Groundwater Application Review Summary Form

Application # G- 18890

GW Reviewer Aurora C Bouchier Date Review Completed: May 13, 2020

SUBJECT: Scenic Waterway Interference Evaluation

Water-Level Trends in Nearby Wells

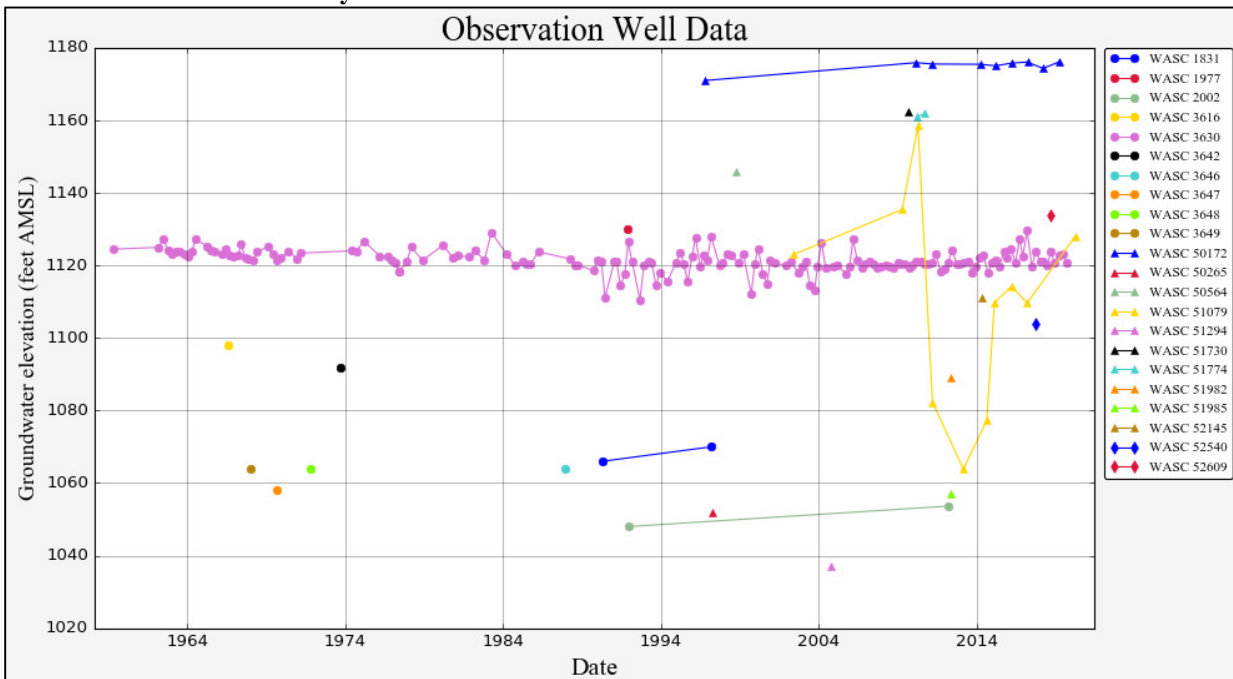
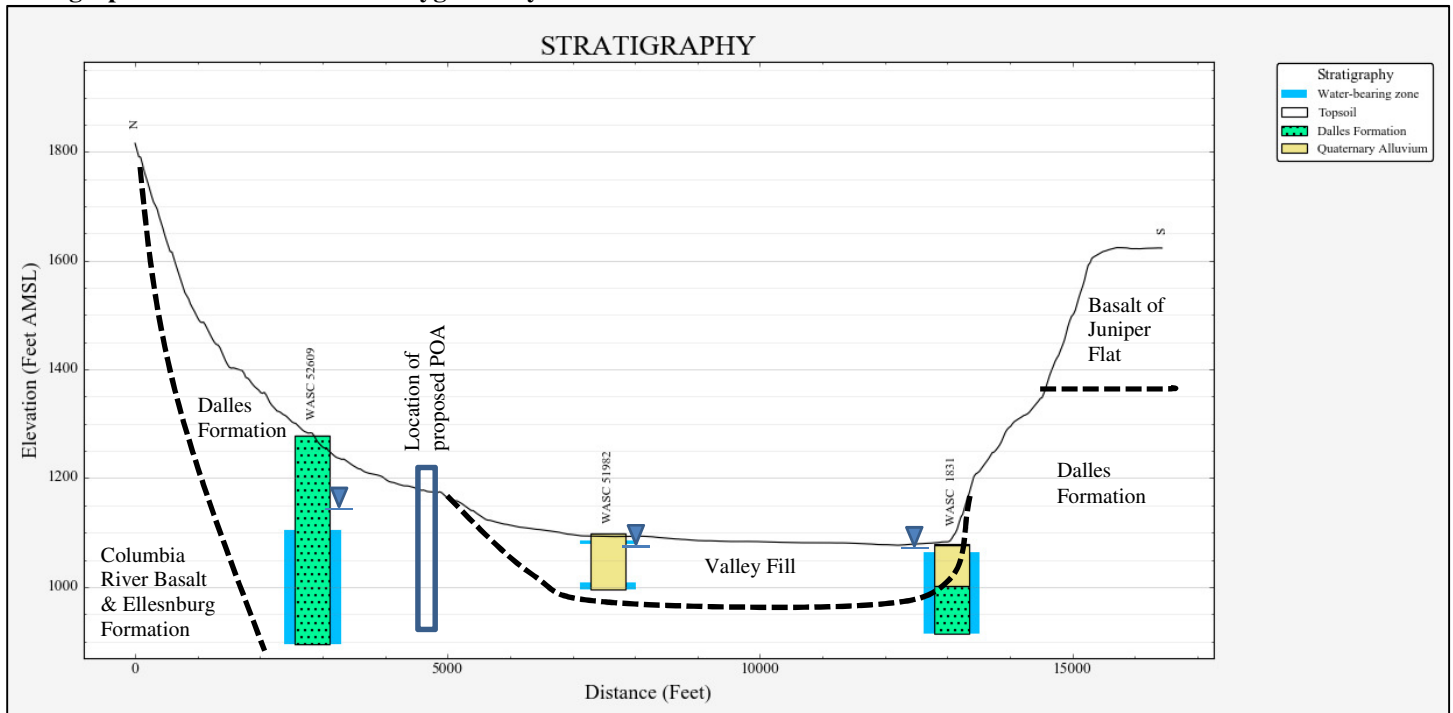
There are a number of nearby wells completed in the Dalles Formation. WASC 3630 (located on the south edge of Tygh Valley) has been monitored since the 1960's and shows no decline and a water-level coincident with nearby reaches of Tygh Creek. Two nearby wells (WASC 51079, located to the northwest along the north flank of Tygh Valley and WASC 51079 located on the hillsides to the northeast) have water-level permit conditions. Water-level measurements from WASC 51079 are relatively erratic, likely a response to pumping and restricted to a small locality. Aside from WASC 51079, the hydrograph for nearby wells indicates overall stable conditions at the current use.

Stratigraphic Cross Section across Tygh Valley

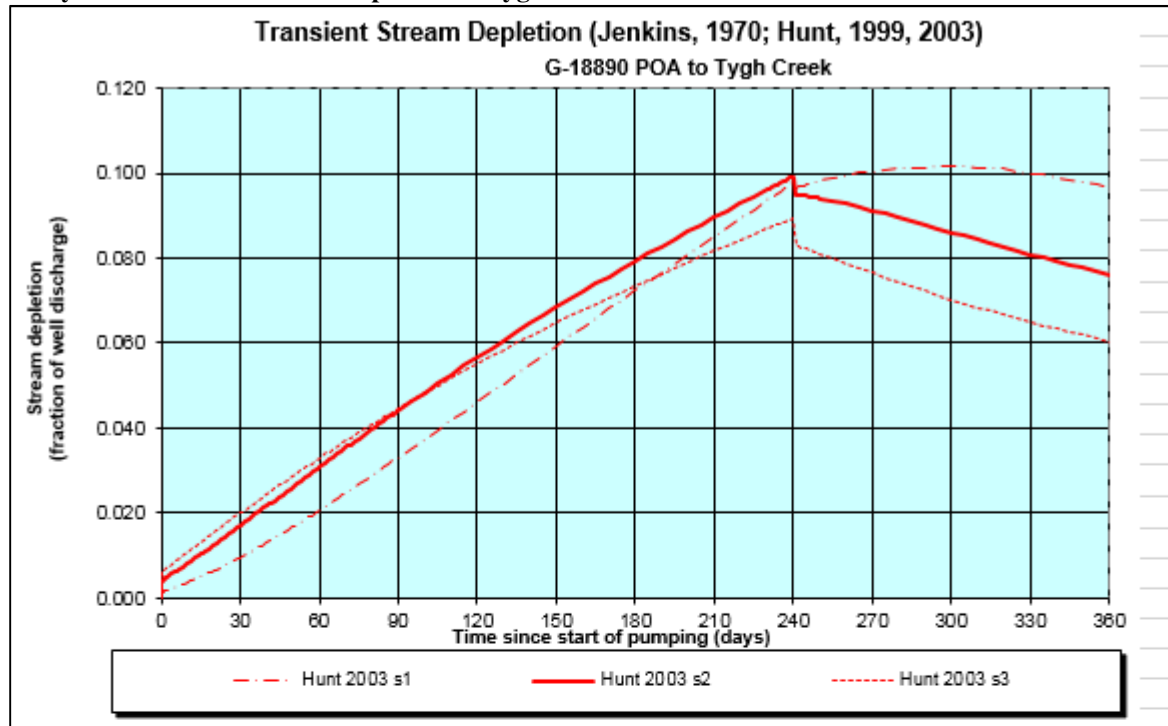
Basis for aquifer hydraulic connection evaluation: The geologic maps suggest that a well at the proposed location will be completed into the Dalles Formation. Wells completed in Dalles Formation located within Tygh Valley or along the southern flank of the valley have water-levels which are coincident in elevation with nearby reaches of the surface waters. Wells completed in the Dalles Formation located on the hill slope to the north of the valley are generally located a larger distance above the valley floor and display water-levels ranging from approximately 10 to 60 feet in elevation above the surface water sources. The proposed POA is located right at the northern edge of the valley floor and will likely have an elevation slightly above to coincident with nearby surface waters.
